# Access Compliance Report

## Public Rights-of-Way

Intersection ID: 43846	Main Street: CURRIER_RD	Cross Street: BRADSTREET_COMMONS_WY	Location: SE
ADA ID: F61B32F31C05	Ramp Type: PerpDiag	Initial Pass/Fail: Fail	Overall Compliance: No
Severity Score: 12.5			
Codes/Mitigation Info/Possible Solution		Field Measurements/Component Compliance

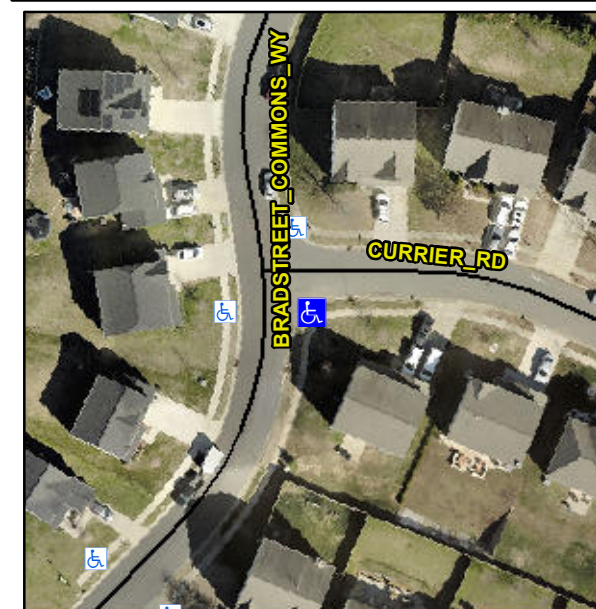
**Not Found, R304.2.2**

Compliance	Description	Data	Compliance	Description	Data
N/A	Ramp Length (in)	47.0	No	Ramp Slope (%)	9.1
Yes	Ramp Width (in)	48.0	Yes	Ramp XSlope (%)	0.4
N/A	Flare Type LT	N/A	N/A	Flare Type RT	N/A
N/A	Flare Slope LT (%)	N/A	N/A	Flare Slope RT (%)	N/A
N/A	Flare Traversable LT?	N/A	N/A	Flare Traversable RT?	N/A
N/A	Landing Length (in)	N/A	N/A	DWS Provided?	N/A
N/A	Landing Width (in)	N/A	N/A	DWS Contrast?	N/A
N/A	Landing Slope (%)	N/A	N/A	DWS Length (in)	N/A
N/A	Landing X Slope (%)	N/A	N/A	DWS Full Width?	N/A
N/A	Landing Curb? (Y/N)	N/A	N/A	DWS Offset (in)	N/A
N/A	Shared Landing?	N/A			
N/A	Gutter Ponding?	N/A	N/A	Gutter Slope (%)	N/A
N/A	Gutter Lip Ht (in)	N/A	N/A	Gutter X Slope (%)	N/A
N/A	Painted X Walk1?	No	N/A	Painted X Walk2?	No
	X Walk 1 Direction	To N		X Walk 2 Direction	To W
N/A	X Walk 1 Width (in)	N/A	N/A	X Walk 2 Width (in)	N/A
	X Walk 1 Slope (%)	1.1		X Walk 2 Slope (%)	0.6
	X Walk 1 X Slope (%)	1.7		X Walk 2 X Slope (%)	2.2

**Remove & Replace Curb Ramp With Two New Directional Ramps or Equivalent.**
